Attachment D

PRELIMINARY SUBDIVISION PLAN
 CABIN JOHN PARK, SECTION 1
 PROPOSED LOTS 221, AND 222
 ELECTION DISTRICT NO. 7 AND 8
 MONTGOMERY COUNTY, MARYLAND

Re: Zoning Matter – Preliminary Plan No. 1-05103 (Cabin John Park Section 1);
Resubdivision of Lot 56A located at 6517 78th St.

RE: Cabin John Park, Section 1
Resubdivision of Lot 56A
Preliminary Plan No. 1-05103

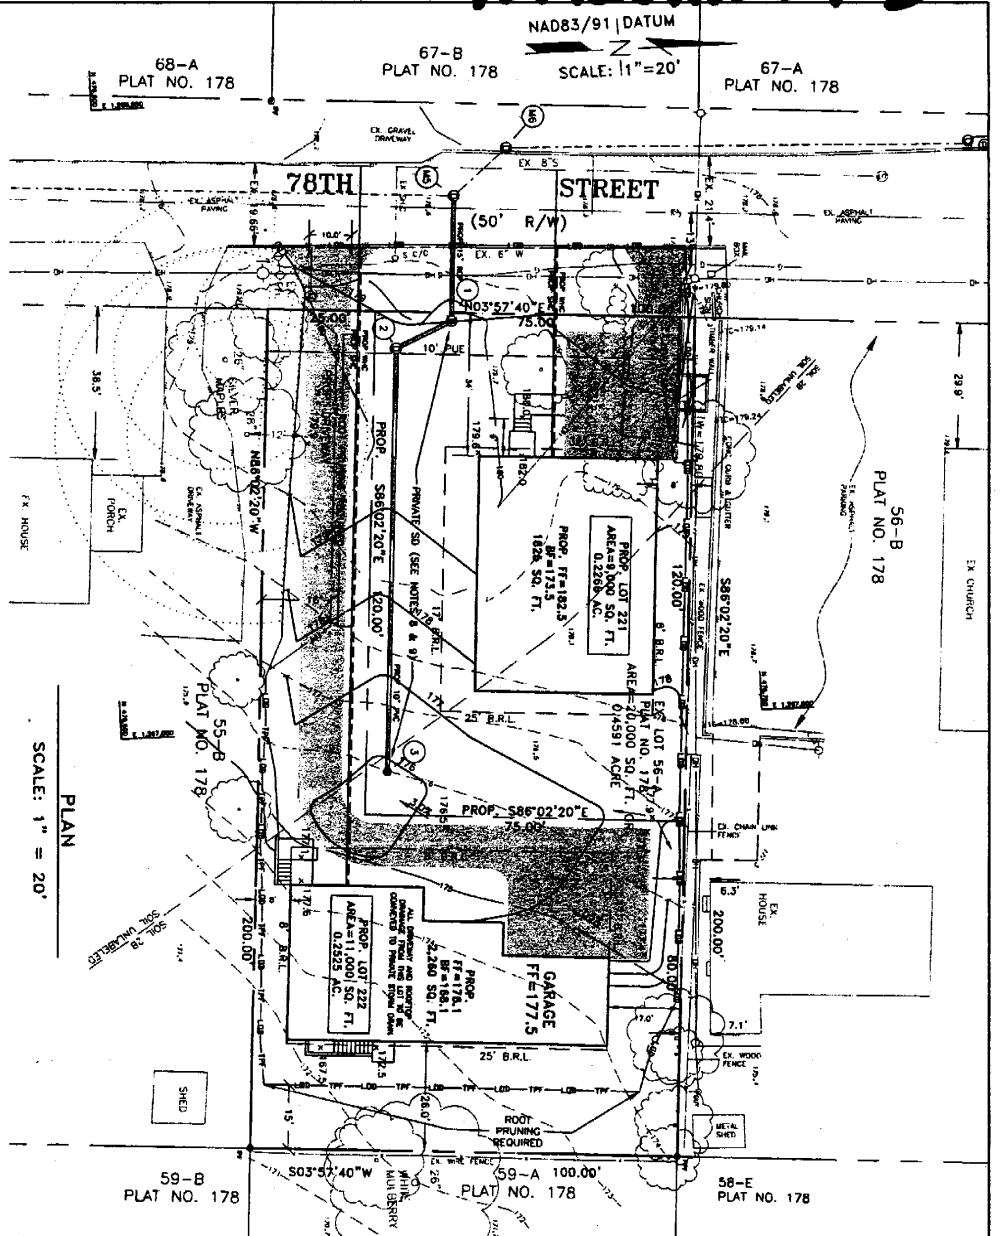
The Plan for resubdivision, we believe, would result in significant property damage due to increased runoff. To accommodate two homes, as the Plan proposes, significant changes in topography have been proposed. The lack of land to absorb the natural drainage of rainfall would be acute.

With the topographical changes, the homes would act as dams, the driveways (especially of proposed Lot 222) would act as funnel swales, and the water could be expected to flow heavily

The applicant was encouraged to explore: a) reconfigure driveway design to minimize disturbance of roots of trees on the neighboring property (to the south), b) use of a shared driveway along the north property line, and c) reconfiguring driveway to the rear lot to reduce impervious surface.

Per Mr. Dunn's findings, we have shifted the location of the proposed driveway farther from the common lot line. The now proposed driveway will be 12 feet from the nearest tree to the common lot line (the 28" silver maple) -- a distance of over 5 diameters from the root base at the ground line. Please see the revised plan. We will employ the recommended tree root pruning and protective fencing per Mr. Dunn's advice.

Further, as shown on our Stormwater Management Concept Plan (which has been approved by MCDPS), we would direct stormwater from the driveway toward the front of the property – filter it across a lawn – and then direct any remaining excess flow into a storm drain. This approach will eliminate shedding storm water from newly introduced impervious surfaces to the rear of the lot, which is low and currently wet during storms due to runoff from our and surrounding lots. Indeed, the proposed situation will affect a reduction in the amount of stormwater that currently reaches the back of the property in its unimproved condition.

There is no water or drainage easement of record that we could find. Nonetheless, our program would not change the grade at the rear for the lot within approximately 25 feet of the rear property line. It would not interfere with existing drainage patterns for surrounding properties.

Our plan would sensitively shed both existing and planned stormwater runoff from the rear of the property toward 78th Street (away from the rear of the lot), thus actually substantially reducing runoff. This has been accomplished by careful siting of proposed houses and modest regrading (a maximum change of less than 3 feet at the front of the proposed house on the rear lot) and by installation of a storm drain. The topography over the majority of the site would remain unchanged and, where changed, is generally within a foot or so of existing conditions.
